# UNITED STATES PATENT AND TRADEMARK OFFICE

APPLICATION NO.	FILING DATE	FIRST NAMED INVENTOR	ATTORNEY DOCKET NO.	CONFIRMATION NO.
10/537,598	06/06/2005	Johan Paul Marie Gerard Linnartz	NL 021217	5023
24737 7590 10/15/2008 PHILIPS INTELLECTUAL PROPERTY & STANDARDS P.O. BOX 3001 BRIARCLIFF MANOR, NY 10510				
EXAMINER BOLOURCHIL, NADER				
ART UNIT 2611		PAPER NUMBER		
MAIL DATE 10/15/2008		DELIVERY MODE PAPER

**Office Action Summary****Application No.**

## DETAILED ACTION

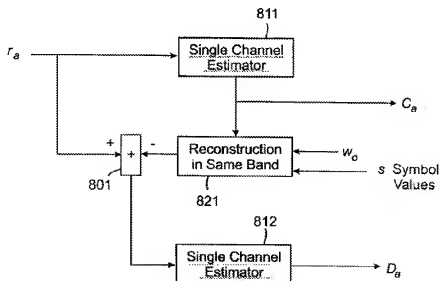
Chennakeshu shows in FIG 8 two pairs of channel estimators 811, 812, or 813, 814. As clearly shown in FIG 6, channel estimator 811 is connected to channel estimator 812 through a summer 801. Similarly, channel estimator 813 is connected to channel estimator 814 through another summer 802.

this is contradictory to the Applicant earlier statements. As disclosed in the last office action in rejection of claim 1, Chennakeshu et al. disclose the channel parameter estimating means in one branch (Fig. 8: 811) are coupled (811 is coupled to 812 through 821 and 801 as shown in Fig. 8) to the channel parameter estimating means in an other branch (Fig. 8: 812), as declared by the Applicant above. (emphasis added):

FIG. 11

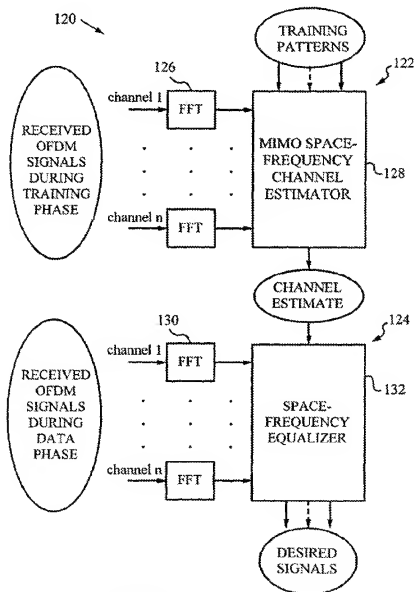
Furthermore, Paulraj et al. disclose the channel parameter estimating means in one branch ("channel 1" in Fig. 11) are coupled to the channel parameter estimating means in an other branch ("channel n" in Fig. 11) (emphasis added):

**Regarding claim 1**, Paulraj et al. et al. disclose diversity receiver having multiple antenna receiving branches (col. 8: lines 59-64), wherein each branch (Fig. 9: 82A ... 82X) has estimating means for estimating (128, "CHANNEL ESTIMATE", and 132 in combination with FFT of Fig. 11) at least a receiving channel parameter ("DESIRED SIGNAL" in Fig. 11), and wherein first parameter estimating means in one branch ("channel 1" in Fig. 11) is directly coupled to second estimating means in an other branch ("channel n" in Fig. 11) for using at least a part of the channel parameter estimate in the one branch ("FFT" 126 of "channel 1") as an aid for estimating at least a receiving channel parameter in the other branch ("FFT" 130 of "channel n").

**Regarding claim 8**, Paulraj et al. disclose method for receiving a signal (Fig. 9) comprising the acts of receiving the signal is received through multiple antenna receiving branches (Fig. 9: 82), in each branch (Fig. 9: 82A ... 82X) estimating parameters about a received channel to form channel estimation results, directly exchanging the channel estimation results between a first branch and a second branch (output of "CHANNEL ESTIMATE" due to "channel 1" in Fig. 11 using first channel estimation results about a first received channel from the first branch as an aid ( $C_a$  through 821 and 801 is input to 812 in Fig. 8) for estimating the parameters about a

second received channel in the second branch and forming second channel estimation ("DESIRED SIGNAL" due to "channel n" in Fig. 11).
